# BULLETIN # 0 9

**PROJECT:** Harrison Recreation & Community Center – PHASE 2  
Harrison, NY

**RE:** Remove Air Purifiers

Job No. NKGD0207.00 Date 02/16/2024  
 Scale AS NOTED Drawn / Checked HM / RG  
 Sheet Number **M-201**

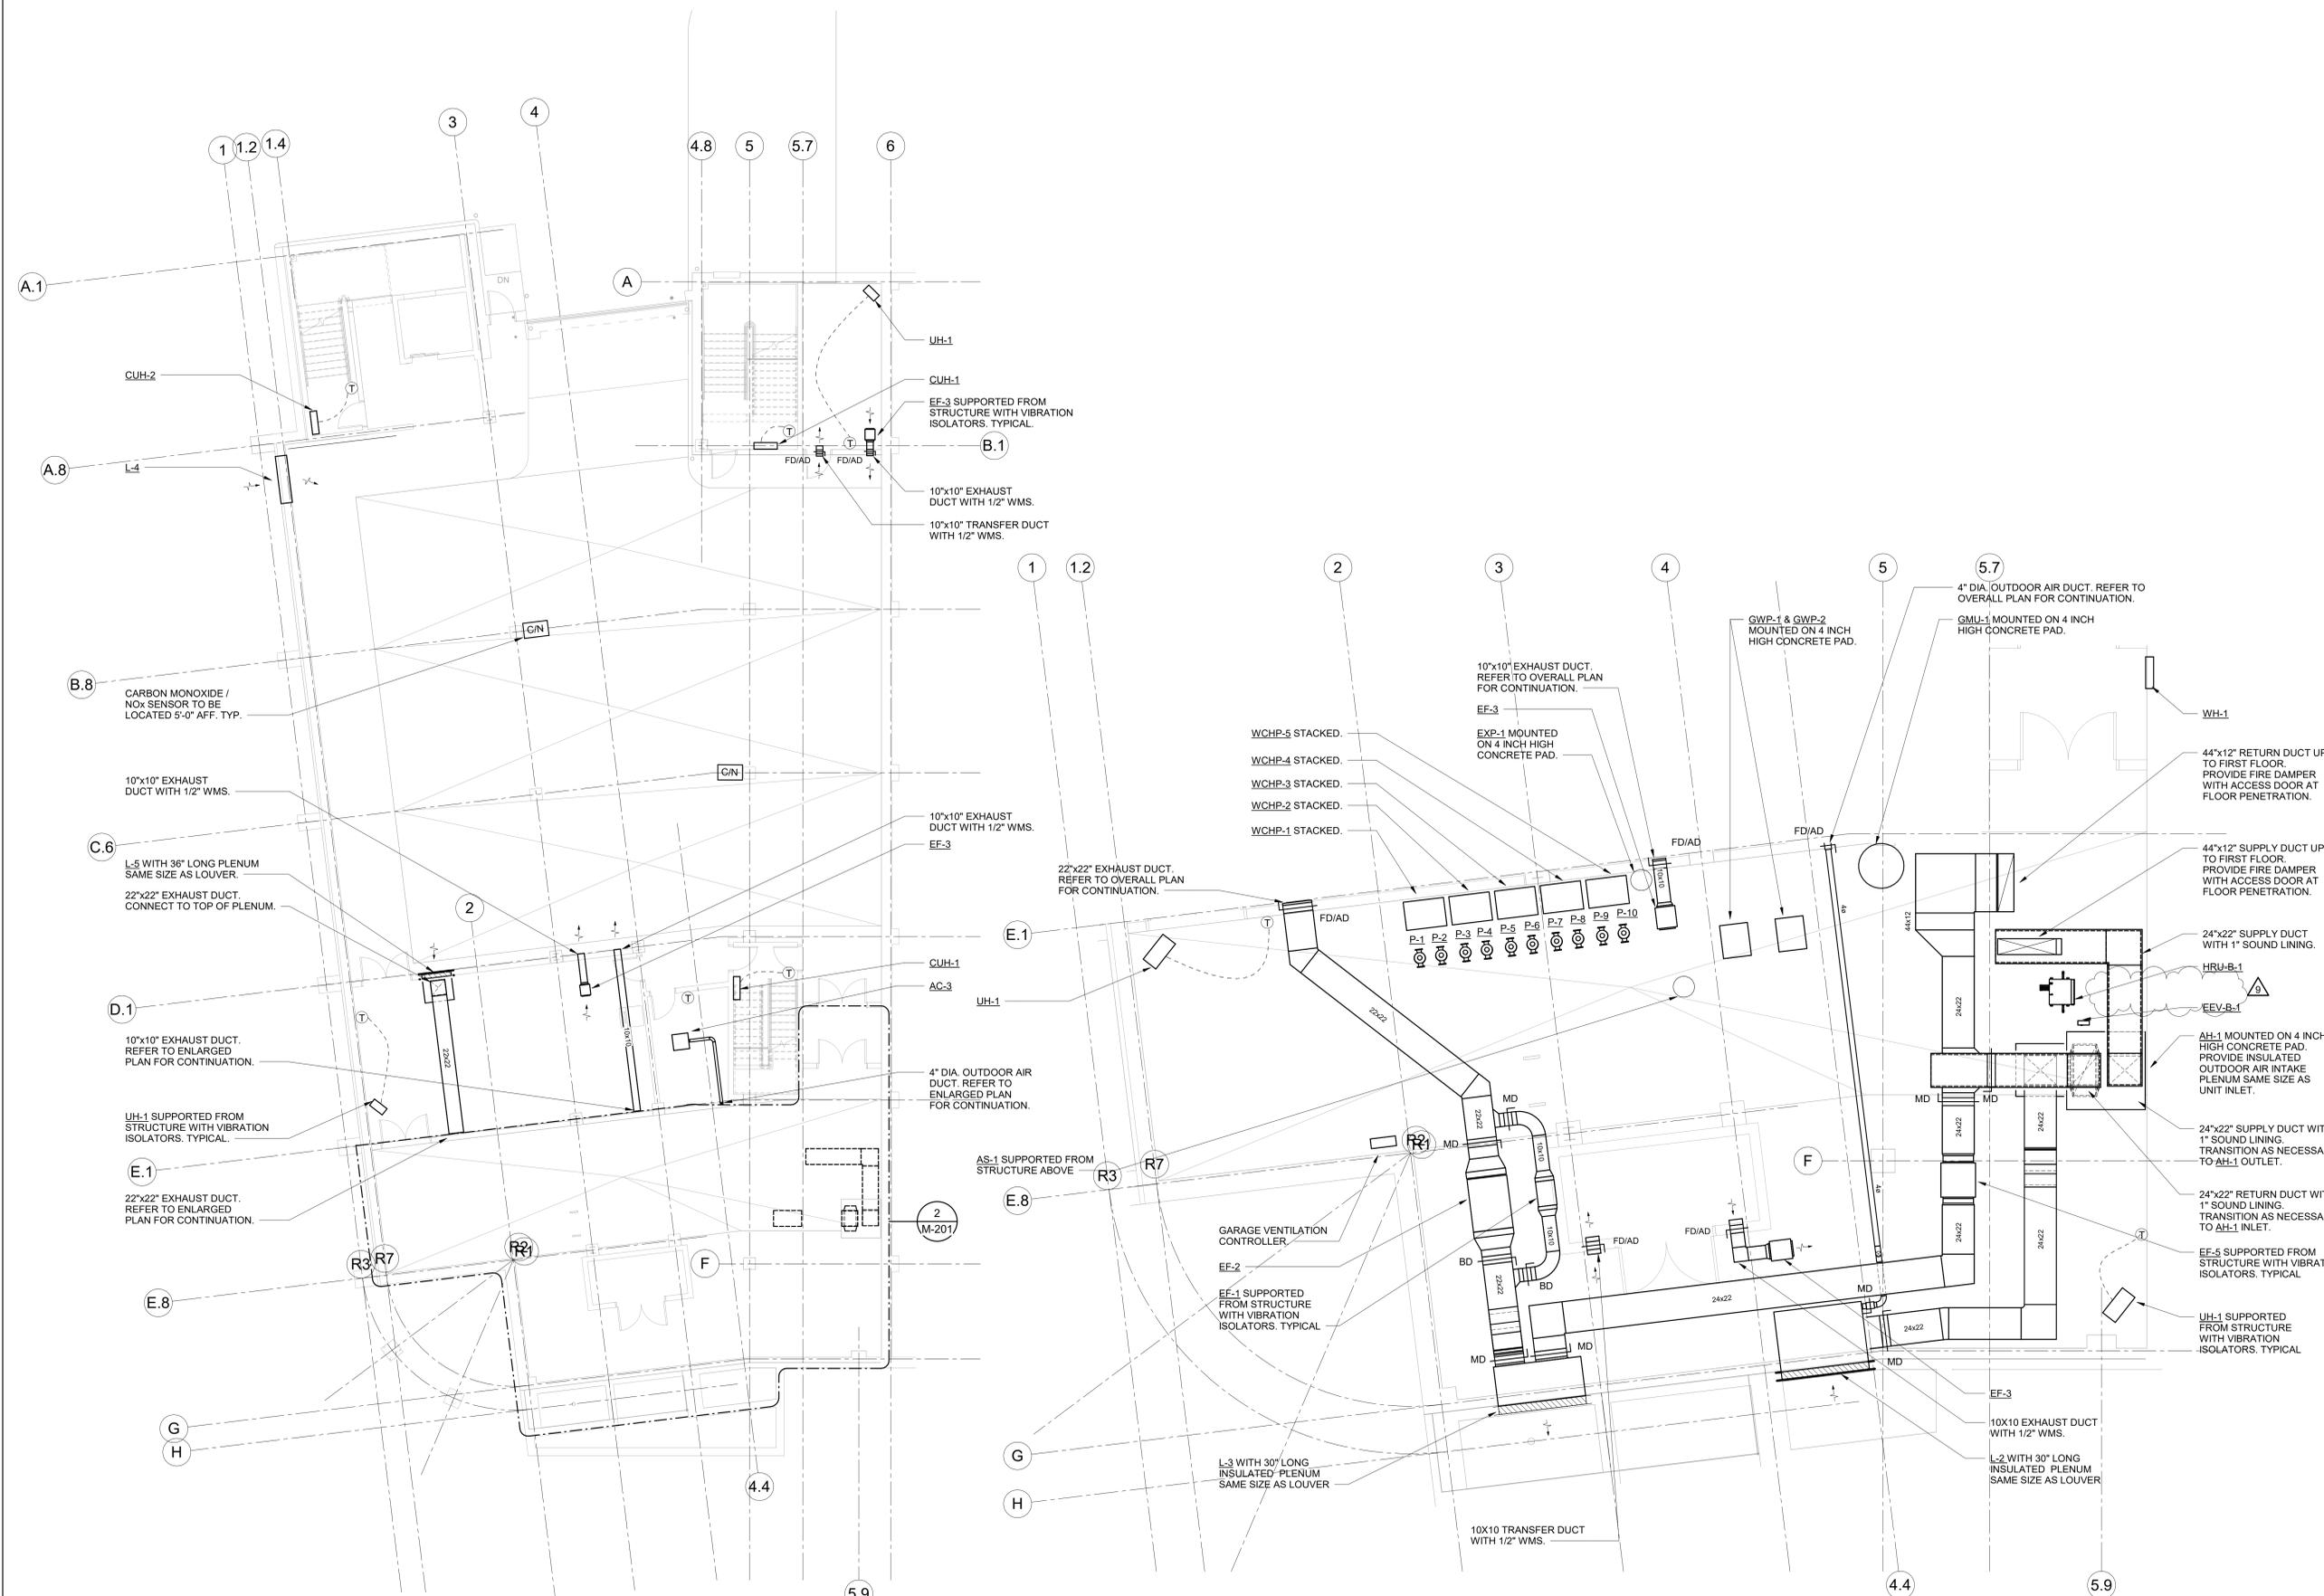
Please provide credit pricing for the removal of the air purifiers as shown on M201, M202, M203, M204, and M603, as they are not required for the project.
